Subject: Integrated Overflow Abatement Plan Modification
DOJ Case No. 90-5-1-1-08254

Integrated Overflow Abatement Plan Modifications

Subject: Southwestern Parkway Storage Basin
Minor Project Modification
IOAP Project No. L_OR_MF_105_M_13_B_A_0
DOJ Case No. 90-5-1-1-08254

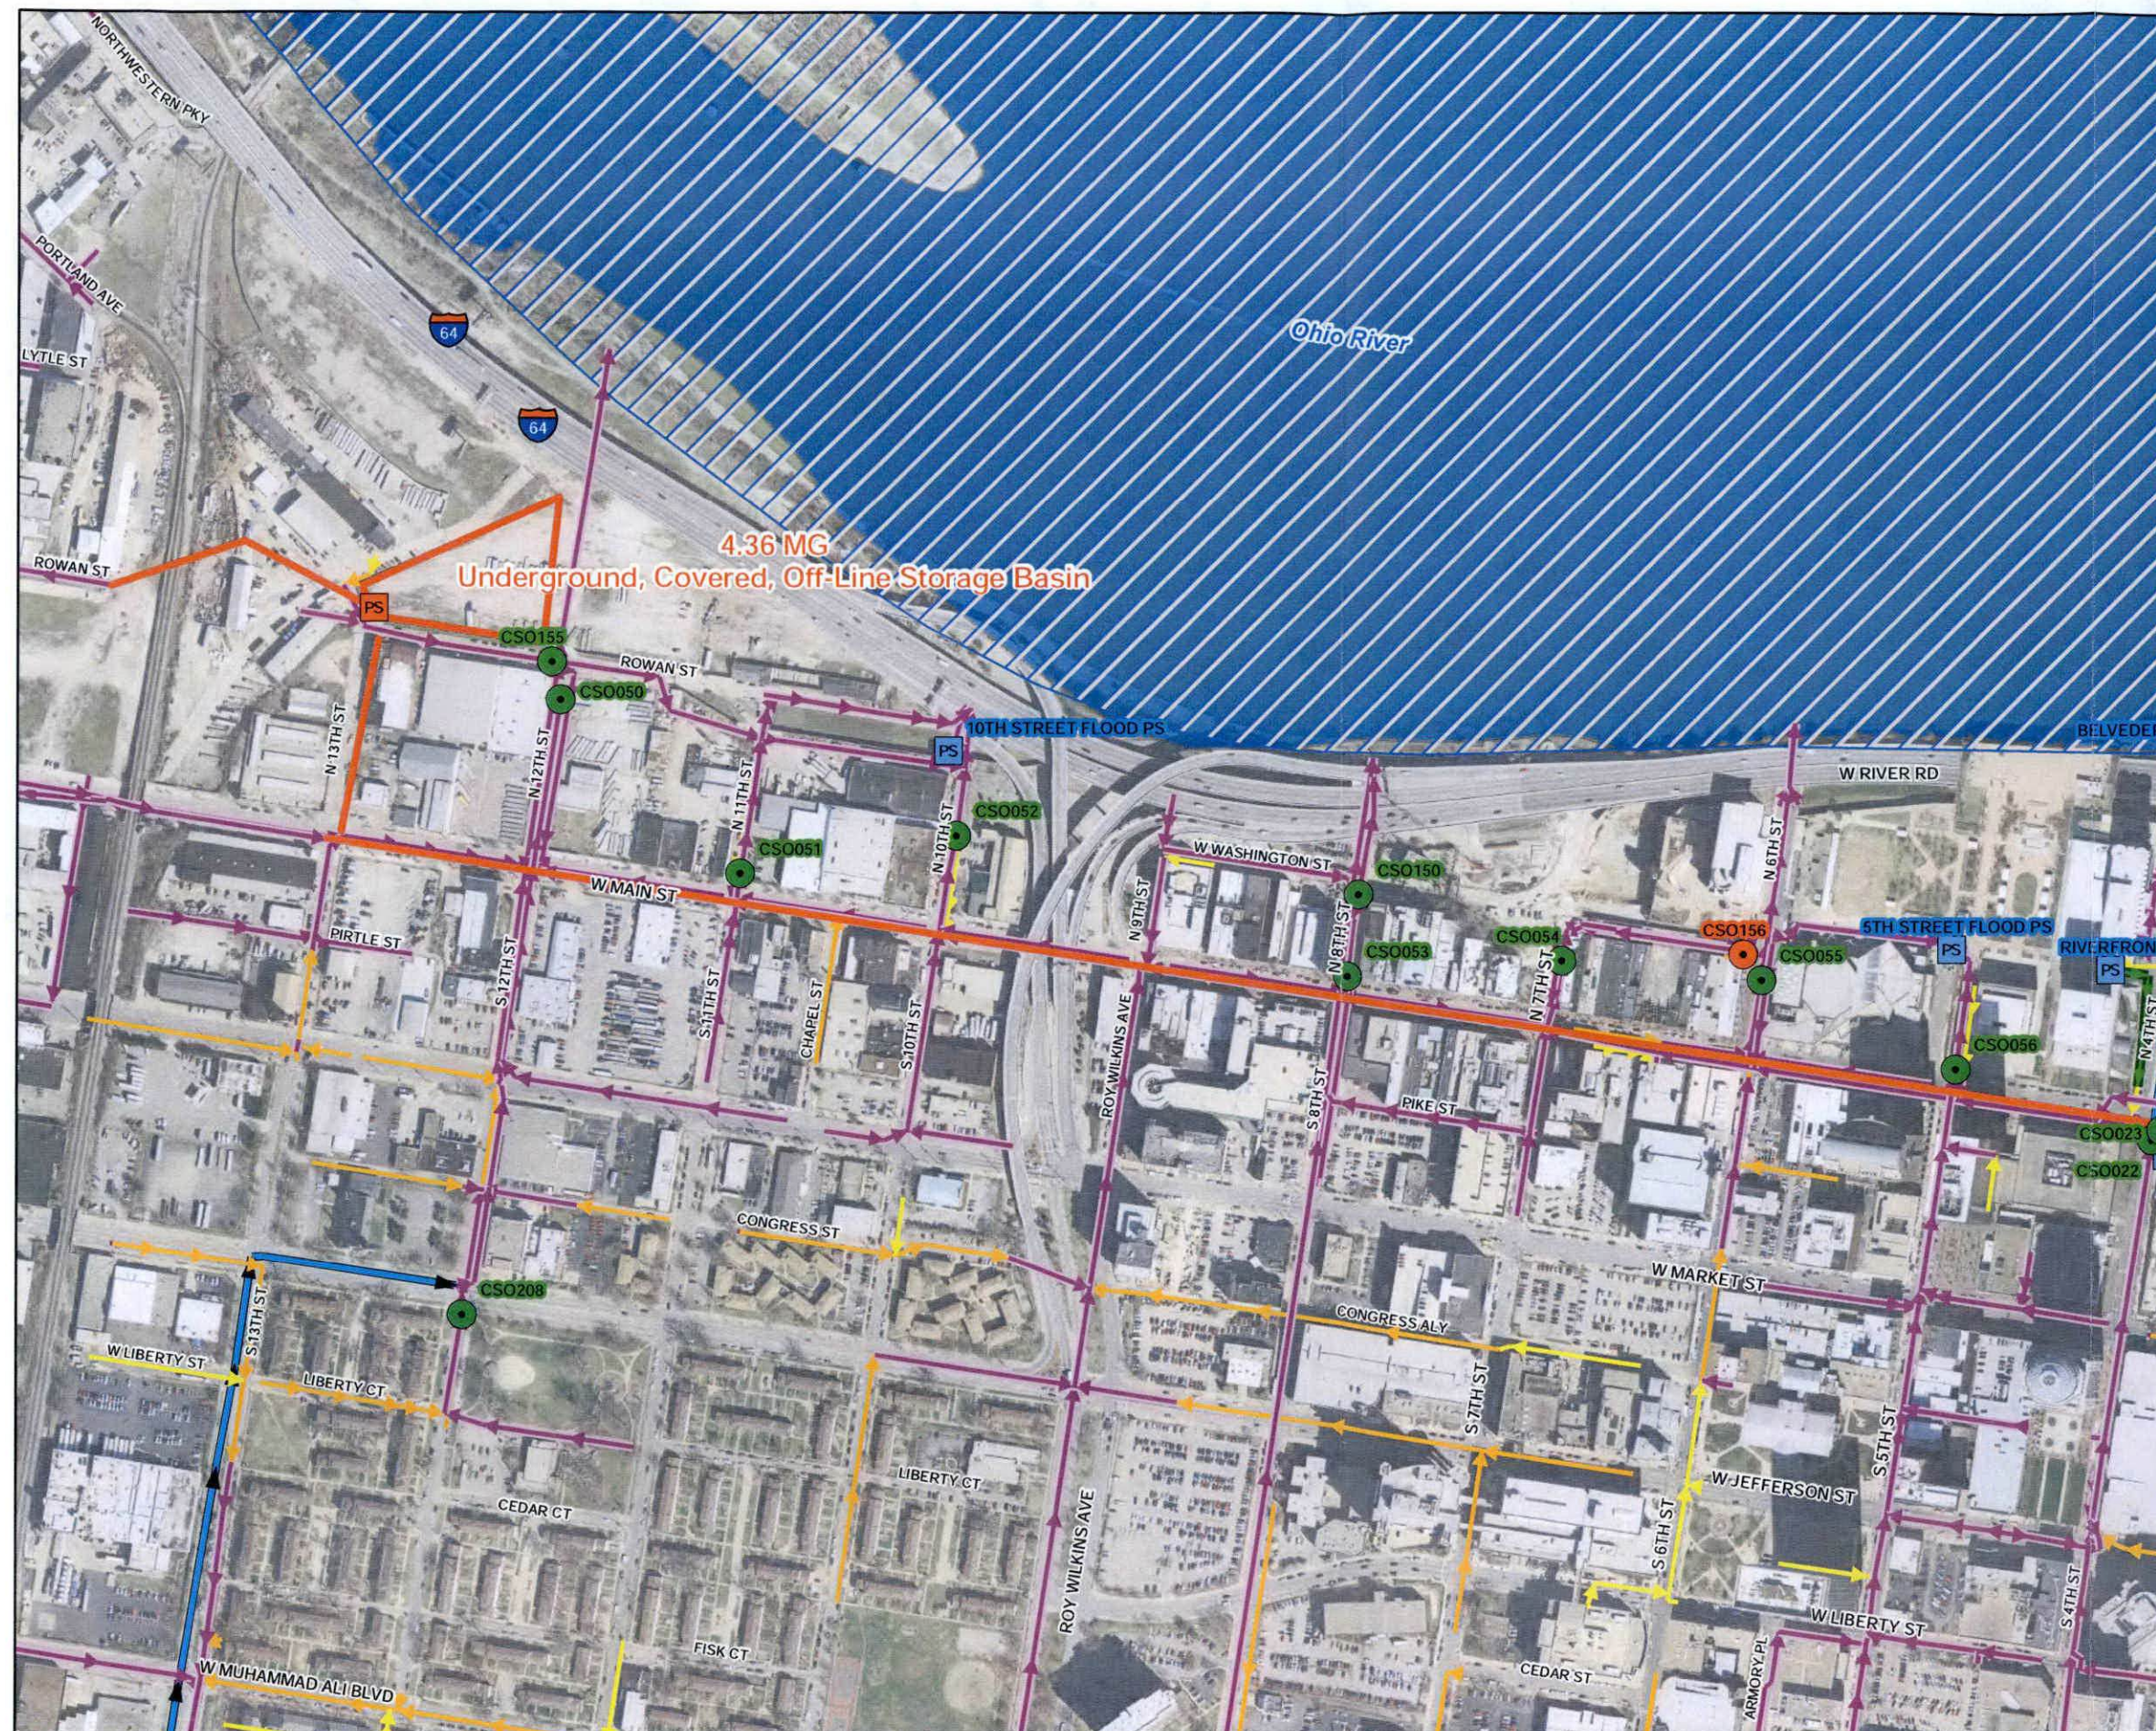
This project modification request includes increasing the 13th Street and Rowan Street Storage Basin size from 4.36 MG to 9.8 MG. The level of control is proposed to remain at 8 overflows per year in the typical year. The larger size does not reduce CSO occurrences significantly, but does provide a reduced residual AAOV. No change in project completion date is proposed.

Project Description: This project includes a large conveyance line from multiple CSOs and 4.36 MG underground covered concrete basin to reduce overflows to 8 overflows per typical year. This project also includes weir modifications to CSO 023 and 058. Two routes and costs for the conveyance line have been identified. The first route involves micro-tunnelling along Main Street, and the alternate route involves traditional open cut sewer installation along River Road. A right-sizing analysis may be used to potentially reduce the size of the basins or eliminate some of the conveyance lines.

Project Description: This project includes a large conveyance line from multiple CSOs and 9.8 MG underground covered concrete basin to reduce overflows to 8 overflows per typical year. This project also includes weir modifications to CSO 023 and 058. Two routes and costs for the conveyance line have been identified. The first route involves micro-tunnelling along Main Street, and the alternate route involves traditional open cut sewer installation along River Road. A right-sizing analysis may be used to potentially reduce the size of the basins or eliminate some of the conveyance lines.
